CITY OF COLUMBIA

AGENDA

- I. Roll Call
- II. Approval of Minutes
- III. Old Business
 1. Case #22-0329 Request from Cole Murphy for facade approval of new townhome construction off Honey Farm Way being a portion of [Tax Map 51 Parcel 58](#).
THIS ITEM WAS DEFERRED FROM A PREVIOUS AGENDA

**HONEY FARMS TOWNHOMES:
ARCH. REVIEW SUBMITTAL**

PLANNING STAFF EVALUATION:

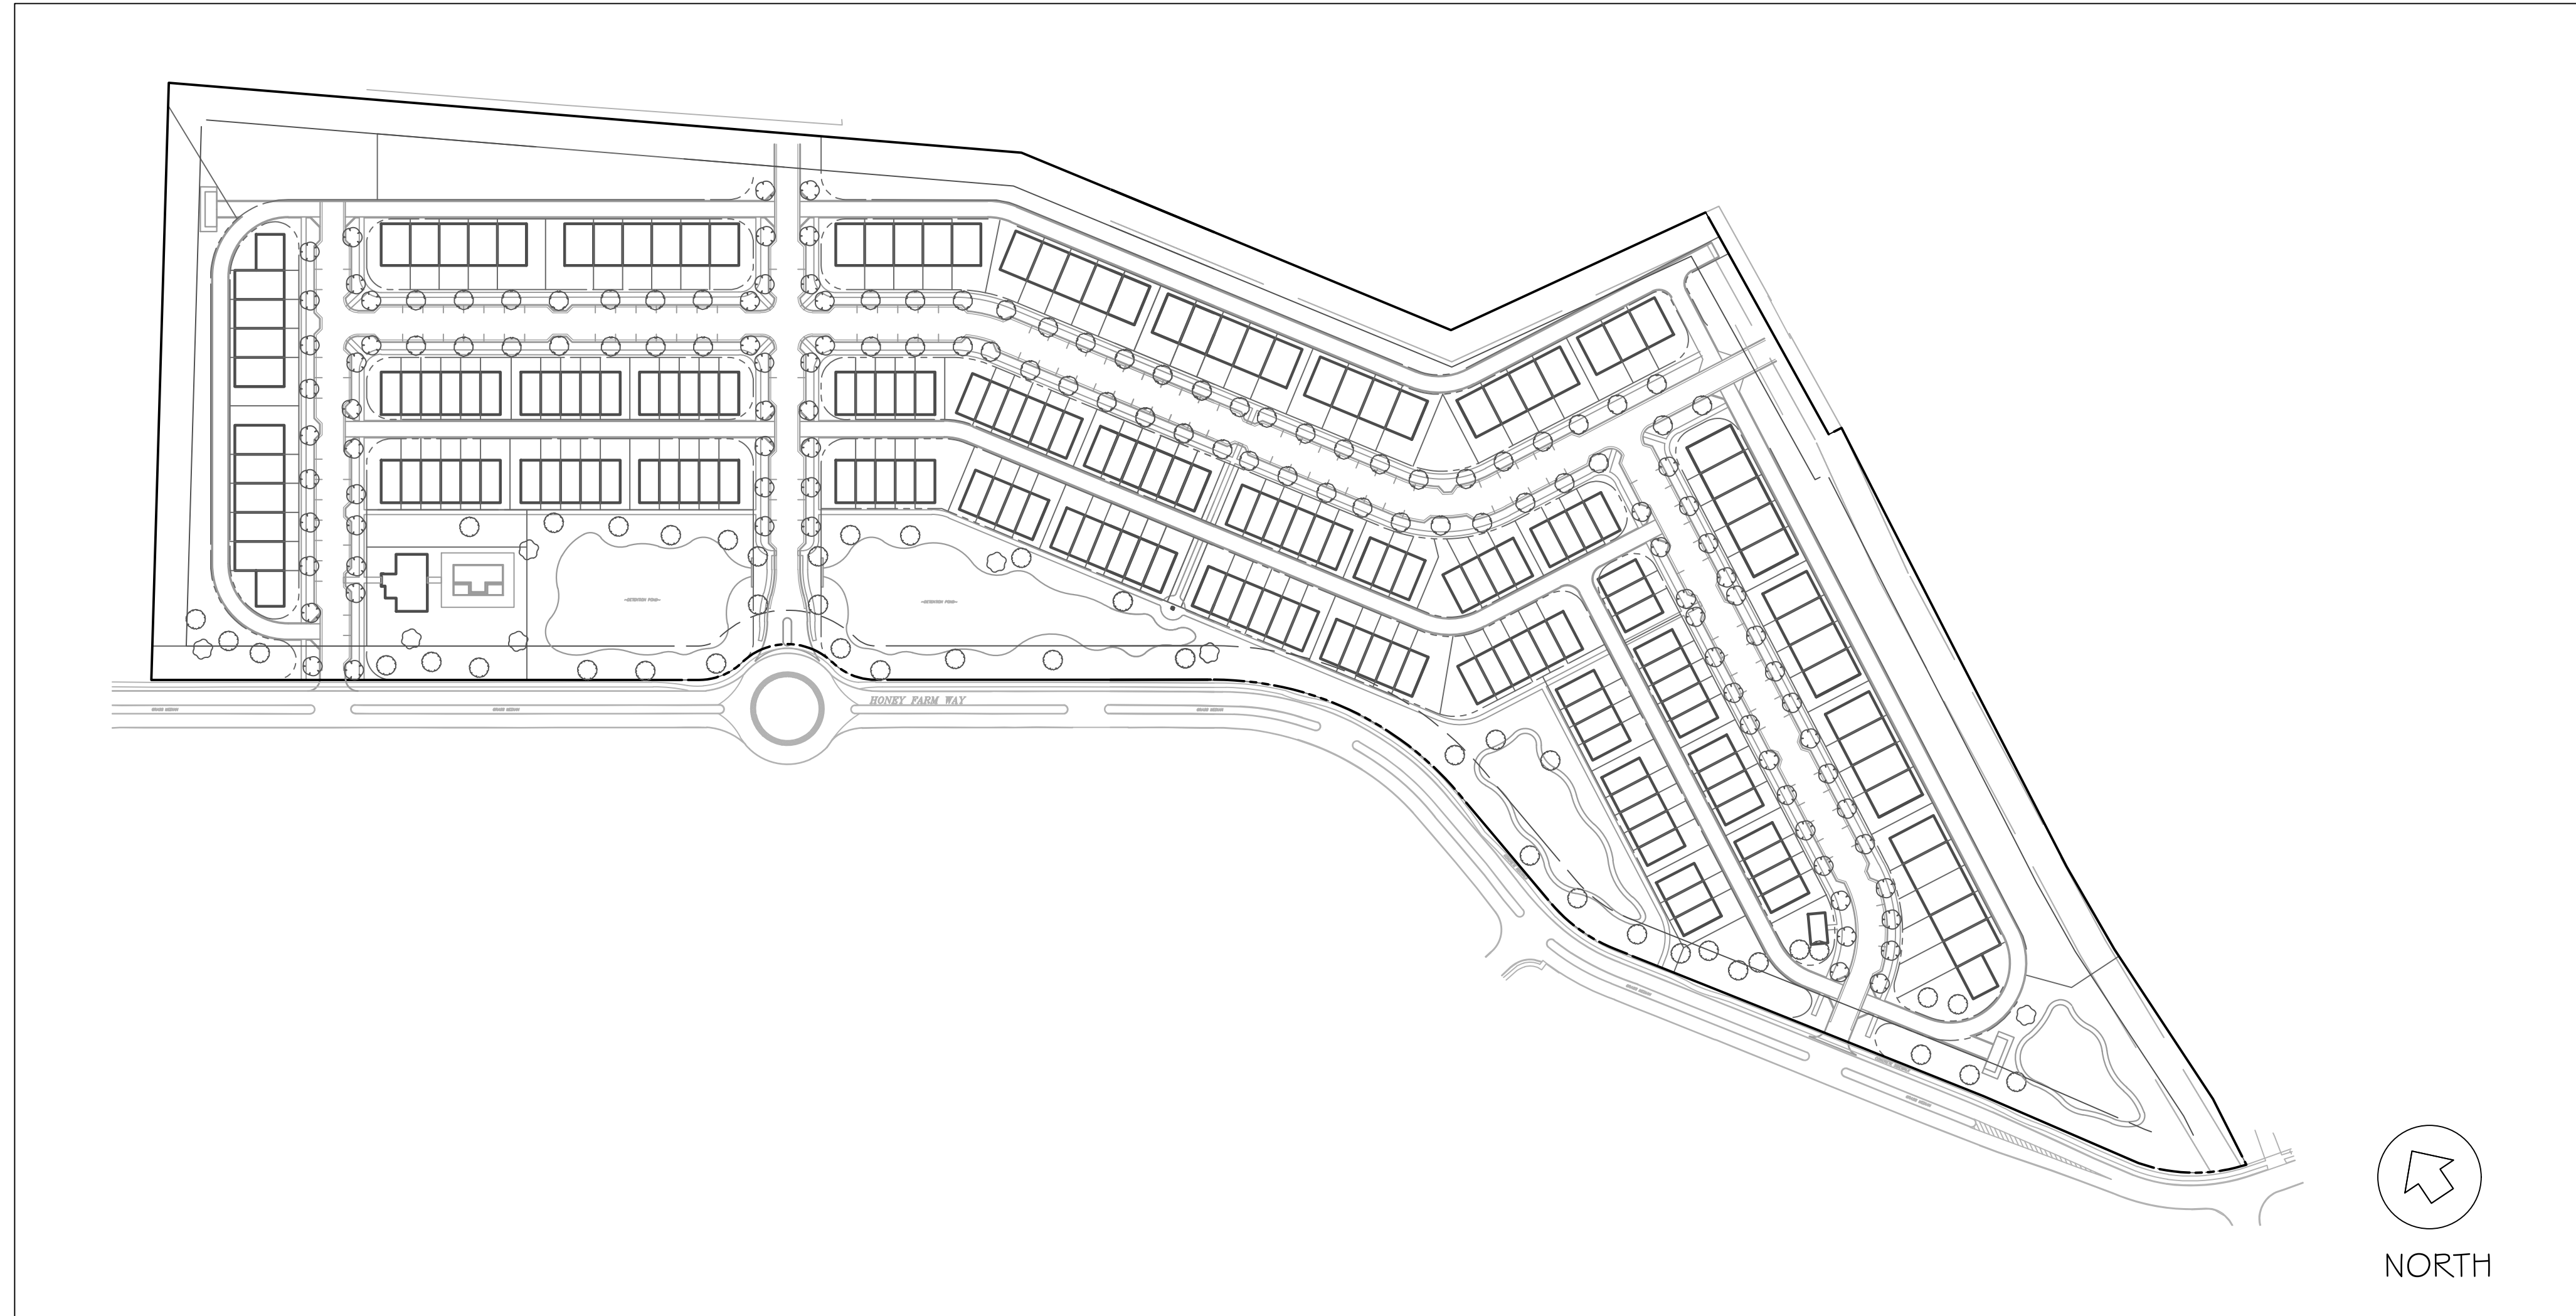
- Primary building materials on façade consist of cementitious siding and brick that are permitted materials on primary building facades.
- Façade articulation is required for a façade greater than 100'. The applicant has selected to achieve this articulation with the use of multiple colors with a material change including a variation among columns, window types, and door designs.

- All elevations require a foundation cladding of brick or natural stone. These details shall be shown on all elevations. This would achieve the building composition requirement of having a defined base, middle, and cap.

- Garage design is required to contain carriage house style doors with a garage door width of 9ft and each garage door having ornamental lighting above it. Garage design does not indicate ornamental lighting fixtures with carriage house style doors with door widths that exceed 9ft. In addition, garages units are required to be at least 10 X 20 for one stall. Floor plan details do not indicate the size of the garage unit as required per the code.

- Window trim details required for top plate if fiber cement board surrounds window; or soldier course above lintel and rowlock course below sill for brick elevations. Elevations that contain brick show a rowlock course below sill, and trim around the windows where Cementous siding is used.

- Indicate details that show minimum 6' clear depth for porch frontages. As discussed at our previous meeting, stoops are accepted for primary façade entry; however, if porches are utilized than they require at least a 6' clear depth to be shown.

- Façade variety is indicated as being broken up by color, noting that no more than one façade shall be on the same block face or within view of the same façade. Applicant has submitted a pattern book indicating how facades will be broken up from block face and view; however, this pattern book only shows the western section of the property with the remainder of the master site plan omitted and not shown.

- Details shall be given regarding porch pier cladding indicating brick or natural stone. Applicant has submitted a porch column design sheet showing column variety include composite wrapped and white pine with options for a brick base and a column option with a tapered design and brick base.

PLANNING STAFF EVALUATION:

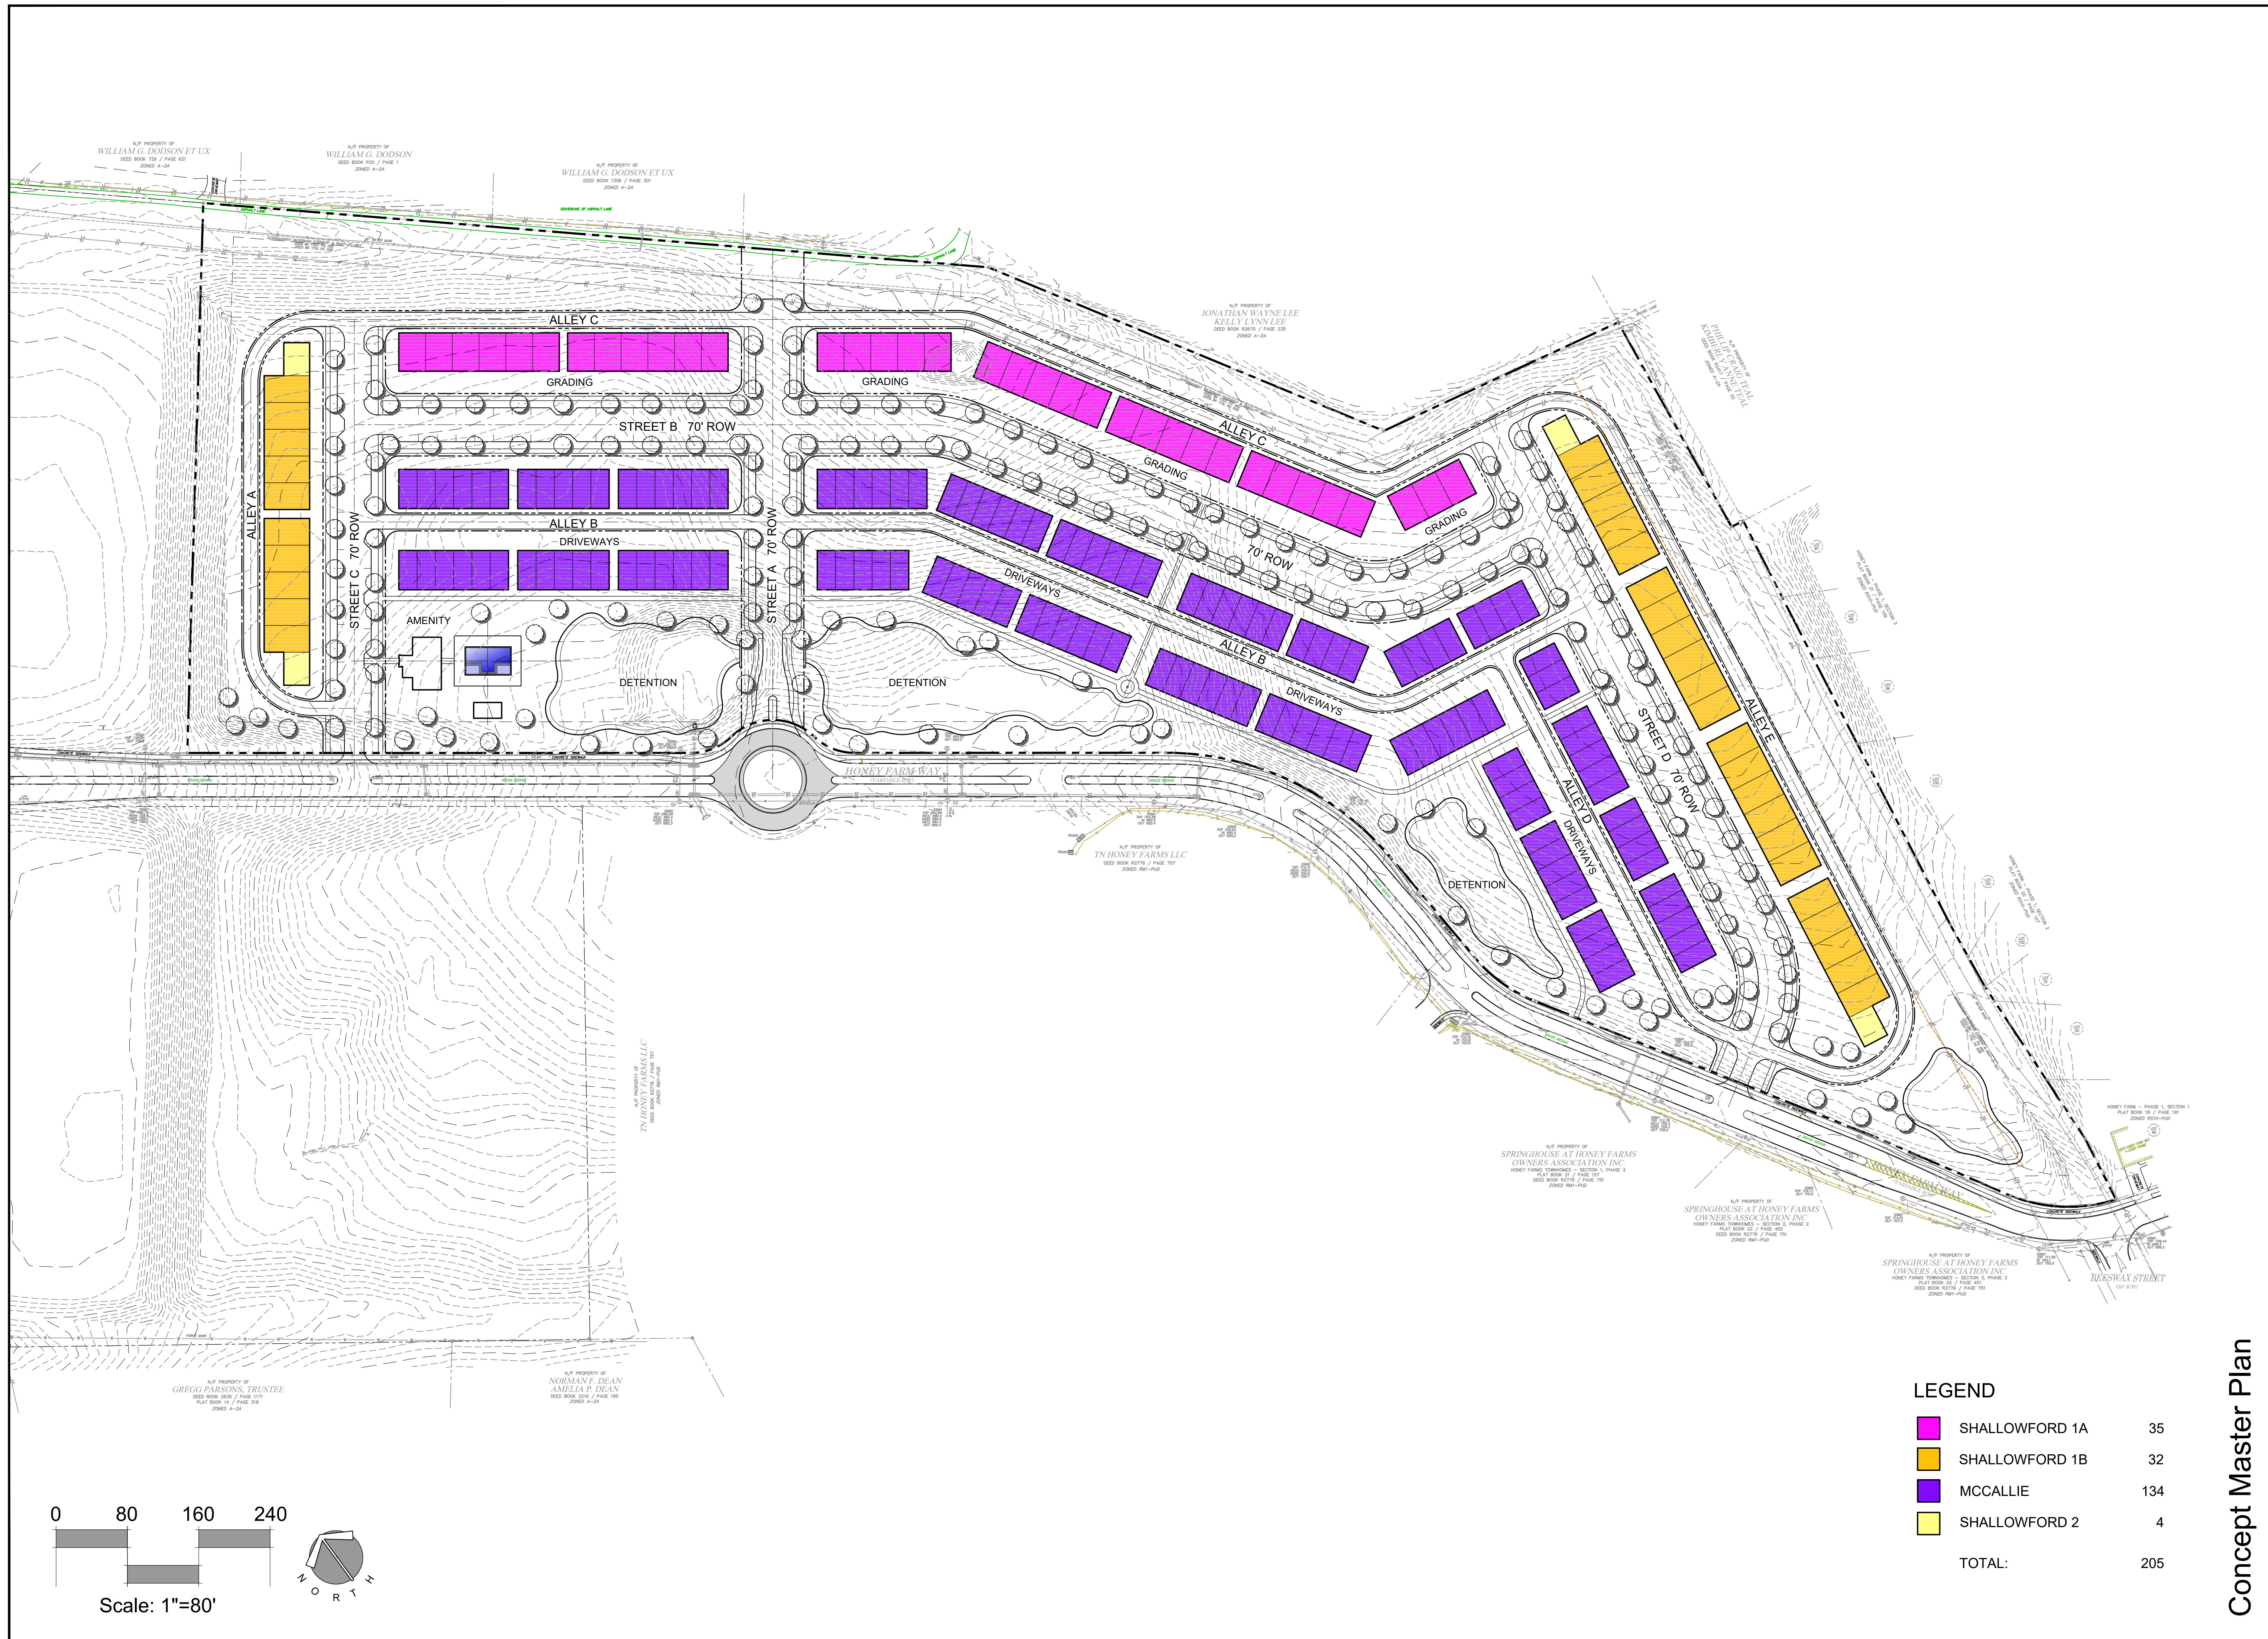
- Primary building materials on façade consist of cementitious siding and brick that are permitted materials on primary building facades.
- Façade articulation is required for a façade greater than 100'. The applicant has selected to achieve this articulation with the use of multiple colors with a material change of a combination of fiber cement board and white brick.

- All elevations require a foundation cladding of brick or natural stone. Multiple elevations do not indicate this foundation cladding requirement. This would achieve the building composition requirement of having a defined base, middle, and cap.

- Indicate details that's show minimum 6' clear depth for porch frontages.
- Façade variety is indicated as being broken up by color, noting that no more than one façade shall be on the same block face or within view of the same façade.

PLANNING STAFF EVALUATION:

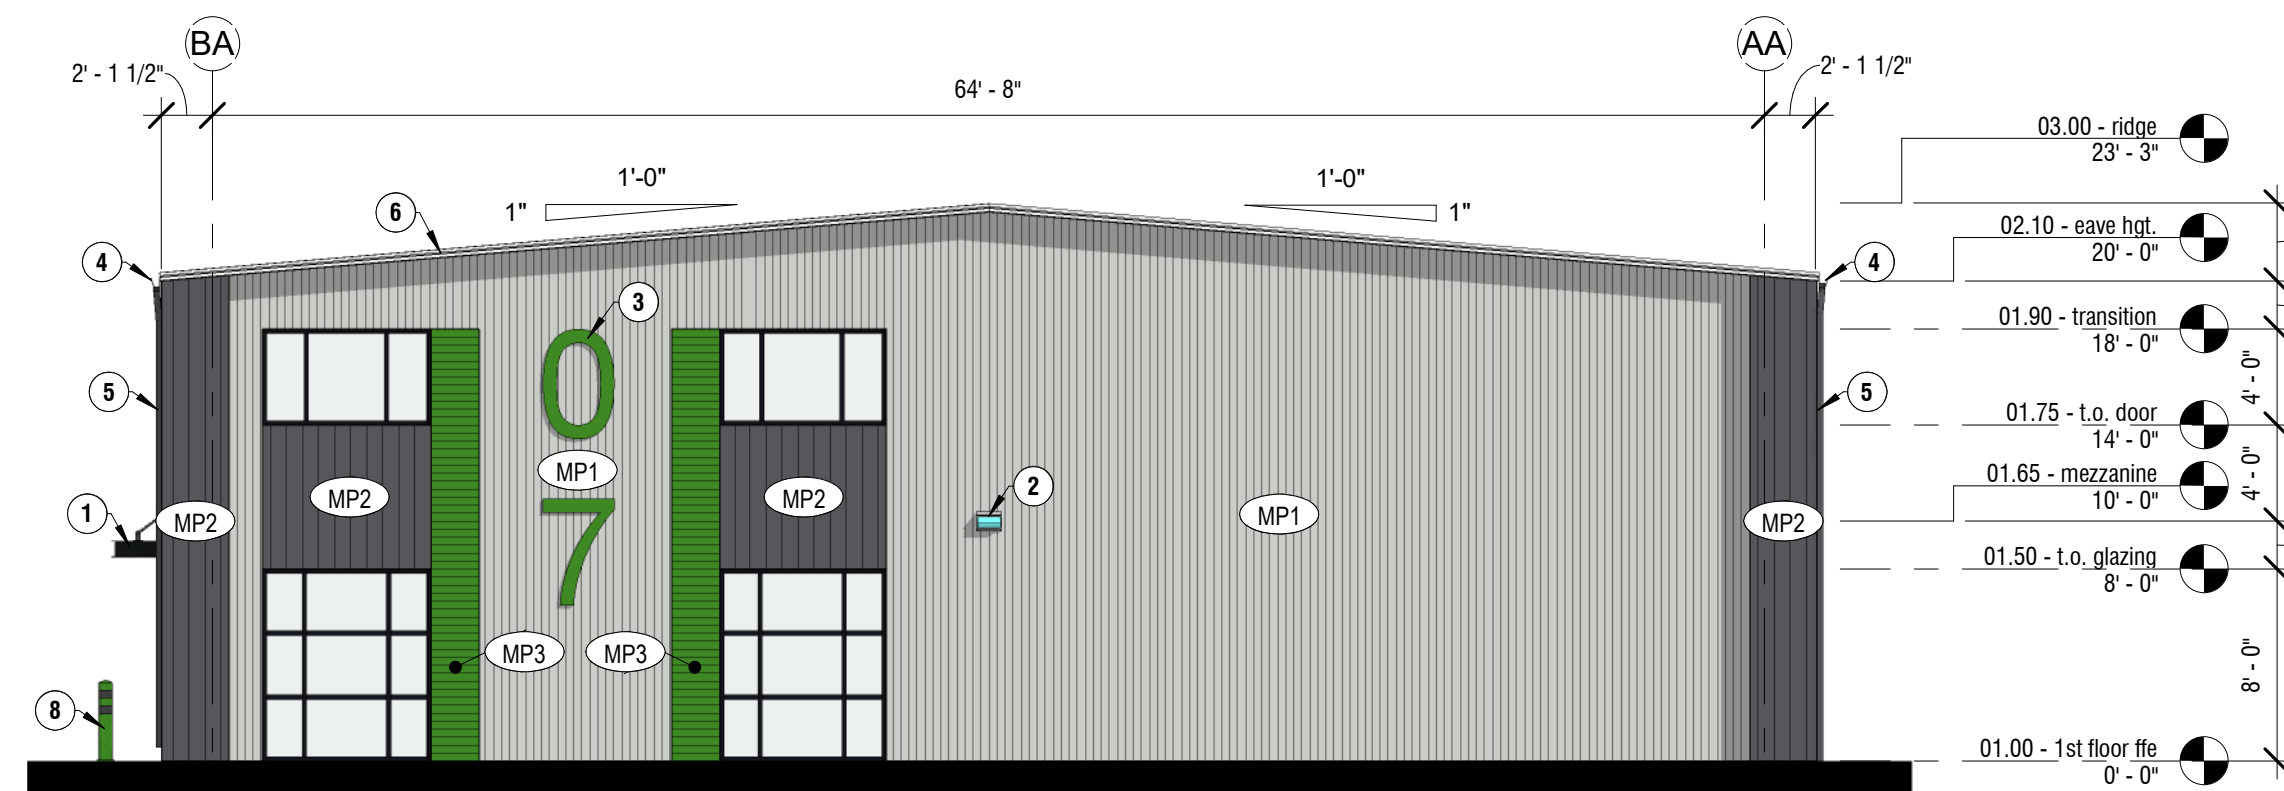
Overall façade material of proposed industrial flex buildings will consist of a combination of metal panels accented by rollup doors and storefront glass. Per the guidelines described, corrugated metal is an approved facade material within an SD LI district for the use of industrial flex buildings.
